**MODIFICATION REQUEST:
CBD and South East Light Rail (MOD 6)**

***Amendment to Condition B47 – Tree
pruning of two trees at the corner of
Alison and Darley Roads***

Environmental Assessment Report
Section 115ZI(2) of the
Environmental Planning and Assessment Act 1979

Figure 3: Option 2, the Proponent's preferred route for shared path and rail alignment, and relationship to the two trees (Source: TfNSW, 2016).

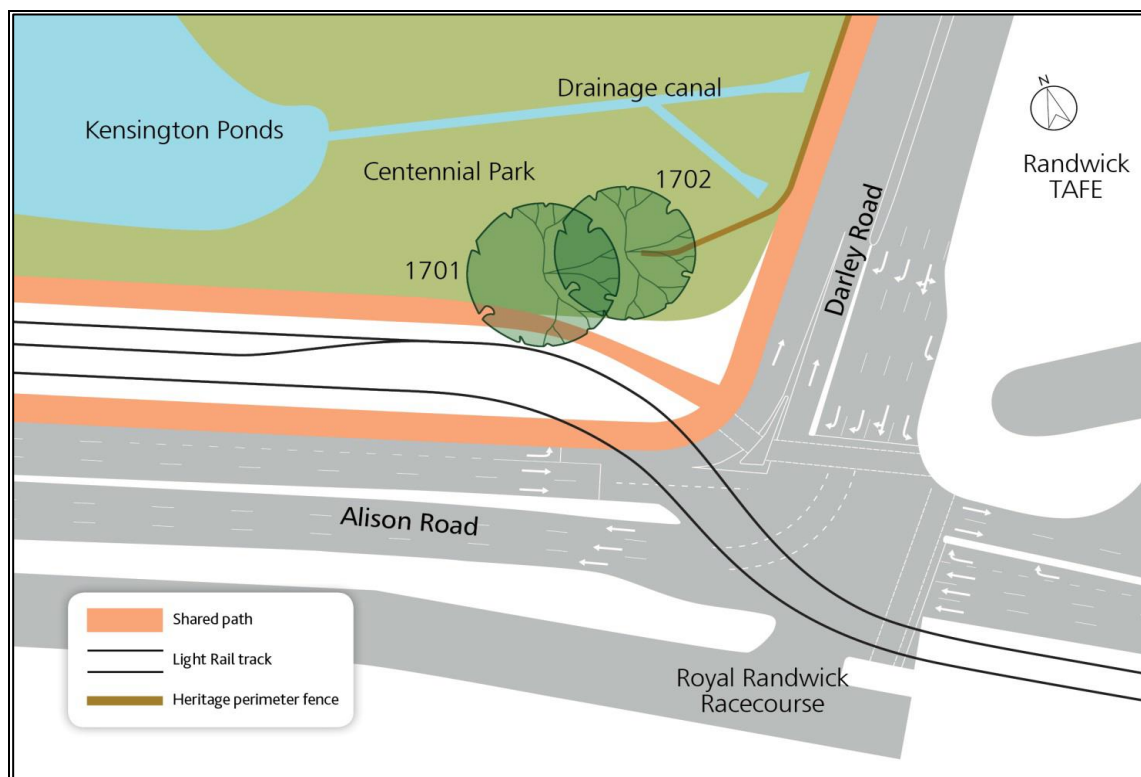
Option 2 (**Figure 3**) was selected by the Proponent as the preferred option as it does not affect operational requirements, traffic phasing or road geometry and would result in minimal visual and heritage impacts over those already assessed and approved. This option would result in the trimming/pruning of no more than 10% of the trees' canopy and root zones, which is consistent with Council's tree preservation policy and recommended by the project's Independent Arborist. This recommendation is based on an arboricultural impact assessment that addresses amongst other matters the condition of individual trees and the tolerance of individual species to disturbance. The trees will remain viable and stable and the Department does not consider the extent of pruning will have a detrimental impact on the long term health of the trees. Accordingly, their associated values, including their contribution to the heritage value of the Centennial Parklands, will be retained.

The Department considers that the Proponent's preferred option is supportable. While Option 2 would impact on the tree canopies, it is considered the best option for minimising construction and operational program impacts as well as to the performance of the Alison and Darley Road intersection. Notwithstanding, the Department considers restrictions are necessary to ensure the long term protection of the trees and has therefore recommended a modified condition that limits the pruning of the trees to a maximum of three metres clearance to the Light Rail overhead wires, and that pruning of the trees must:

- satisfy the requirements of *AS4373 (2007) Pruning of Amenity Trees*;
- be restricted to the minimum amount necessary and no more than 10 per cent of the pre-construction extent of the overhead canopy of each tree;
- not include root pruning of the structural root zone of each tree;
- be supervised by an Arborist; and
- be undertaken in conjunction with management and mitigation measures before, during and after pruning as recommended by the Independent Arborist and included in the Tree Report required by Condition B48.

Figure 4: Option 3, avoiding any impact to the trees and the preferred option for the CPMPT (Source: TfNSW, 2016).

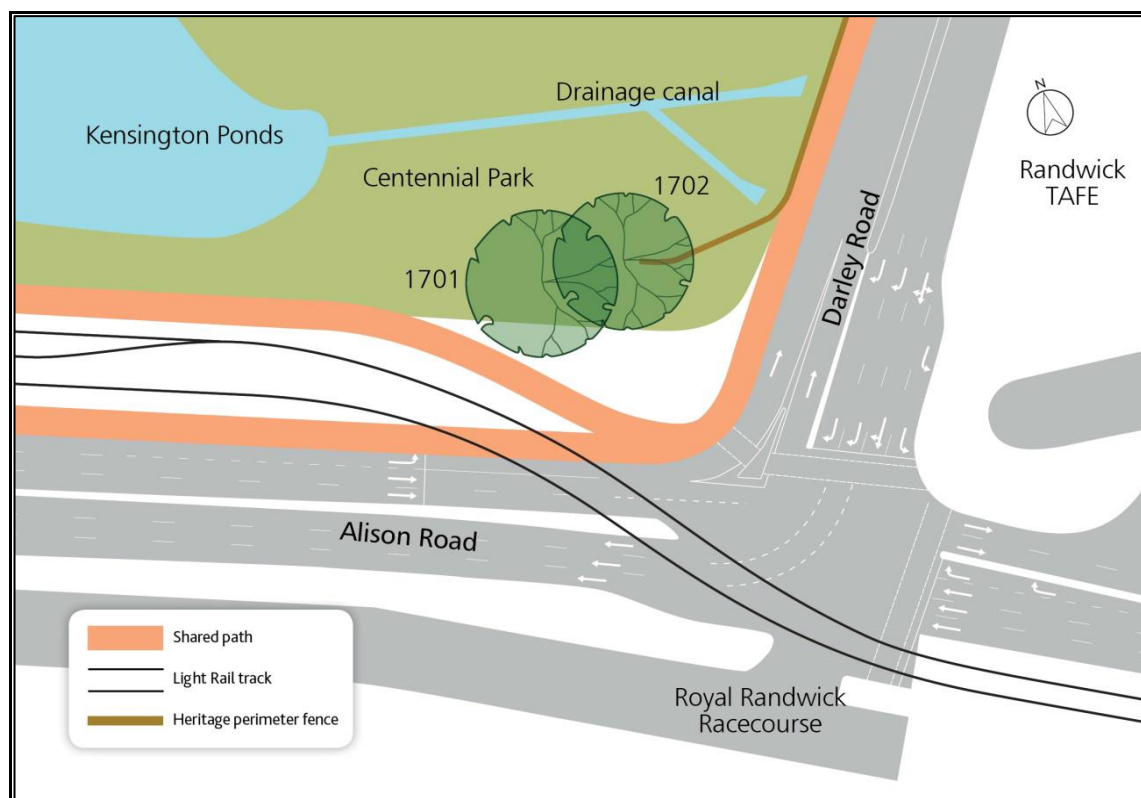
CPMPT indicated its preference for Option 3 (**Figure 4**), which would shift the alignment of the rail track and shared cycle/pedestrian path six metres away from the tree canopy, largely avoiding the requirement for tree and root pruning. While avoiding impacts on the trees, the Proponent determined that this option would have greater impacts on other constraints compared with the other alignment options. Key impacts include disruption to Light Rail construction and operation, and traffic flow through the Alison and Darley Road intersection. Spatial constraints identified include:

- limited space around the Alison Road stop location to accommodate special event ancillary infrastructure (third track and track turnouts) at this stop;
- the location of the Alison Road pedestrian crossing from the Australian Turf Club Gate 1 to Centennial Park and public transport nodes; and
- the requirement to provide sufficient space for track turnouts to the Randwick Stabling facility.

Roads and Maritime Services (RMS) provided a submission that further quantified the traffic and safety constraints at this intersection. RMS found that the increase in the length of the Alison and Darley Road intersection, by up to 25 metres for Option 3, would cause further deterioration of the intersection's performance. RMS consider that the additional setback distance required to accommodate the changes would create further operational delays, increases in queuing lengths and congestion. Option 3 was also found to potentially increase the risks to pedestrians crossing the Darley Road slip lane as sight lines for pedestrians and motorists would be affected.
